Liffey Valley to City Centre Core Bus Corridor Scheme

NTA Observations on
the Dublin City Council
Submission

March 2023

Figure 2 5: Extract from General Arrangement Drawing (annotation added)

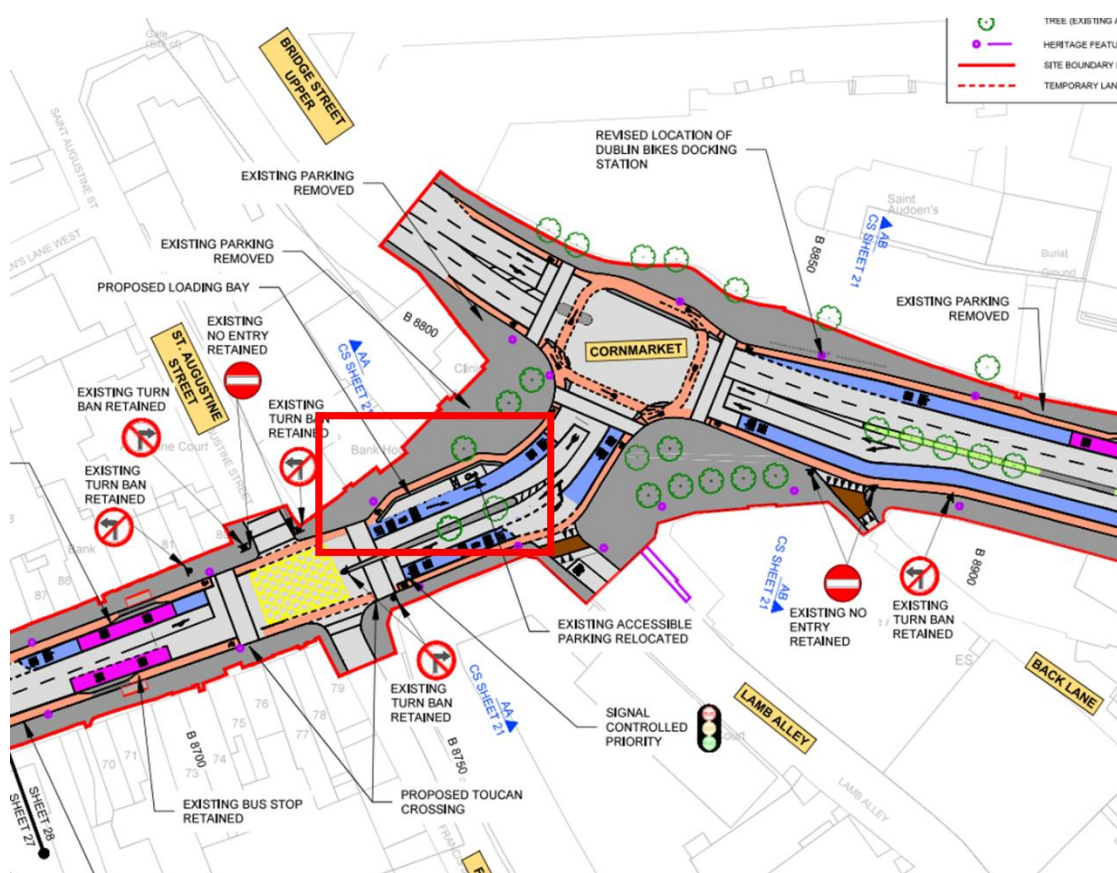
- DCC suggests the removal of loading bay and accessible space outside Farrow and Ball Paints be reconsidered.

As part of the Proposed Scheme is it proposed to provide a new loading bay and accessible parking space on the R810 Cornmarket left turn slip road.
